DOCKET
<u>01-AFC-24</u>
Date: <u>3-31-03</u>
Recd. <u>4-4-03</u>

**REBUTTAL TESTIMONY OF BILL POWERS
IN OPPOSITION TO THE APPLICATION FOR CERTIFICATION FOR THE
PALOMAR ENERGY PROJECT (01-AFC-24)**

Water Resources – Rebuttal to Testimony of Joe Rowley

PROJECT DESCRIPTION - Figure 2
 Otay Mesa Generating Project - Site Cross Section

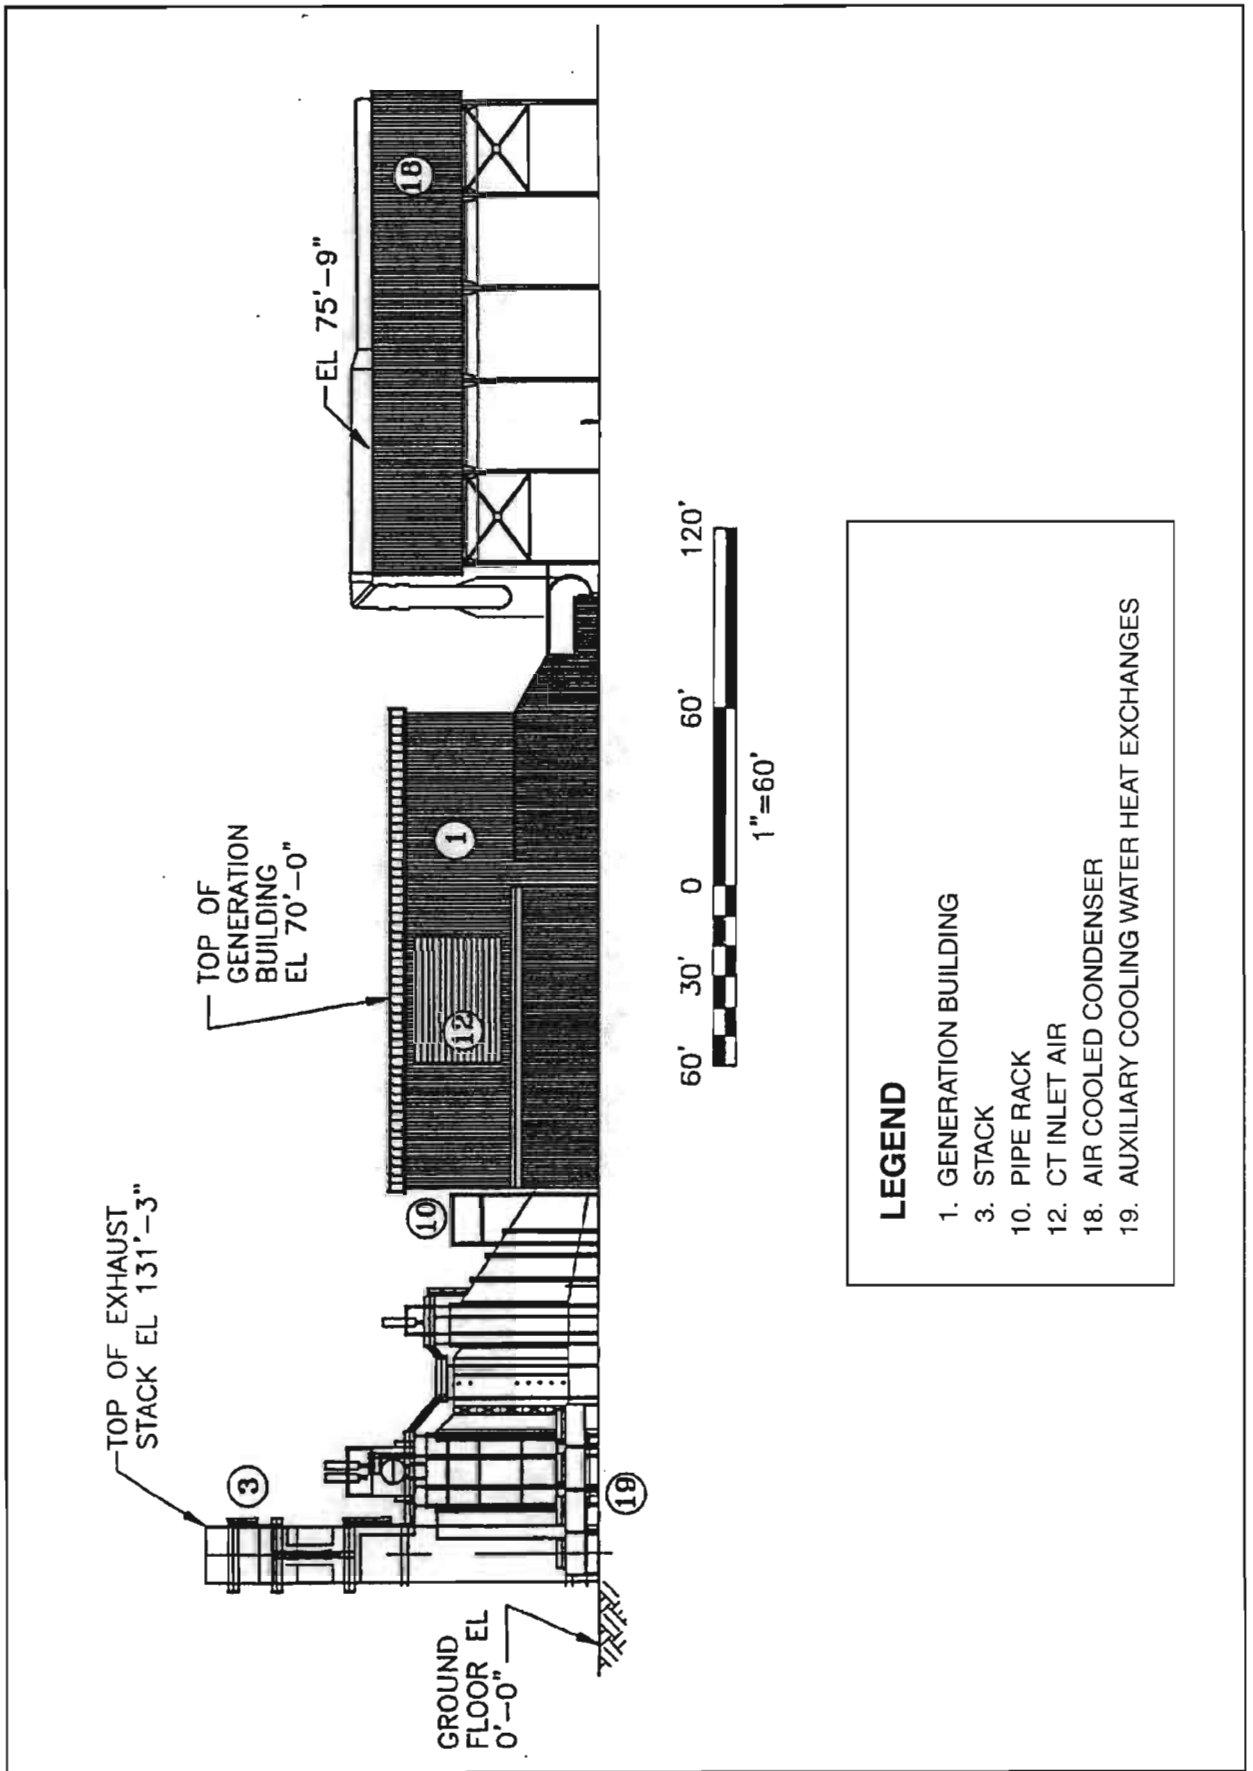
Pg. 11, Visual Impacts and Noise, . . . an air-cooled condenser would be about 300 feet wide, 300 feet long, and 100 feet high . . .

This is an incorrect statement and implies that dry-cooled plants such as Sempra's El Dorado Plant built in isolated areas would be built in the exact same way in the middle of an urban area. The only power plant currently permitted for construction in San Diego County is the 540 MW dry-cooled Otay Mesa Project. The overall height of the ACC at Otay Mesa is 76 feet. The plant is located on the outskirts of San Diego. An elevation view of the Otay Mesa Plant is attached. A height-optimized ACC will fit on the Palomar site based on a review of the plot plan provided in the November 2001 Application For Certification.
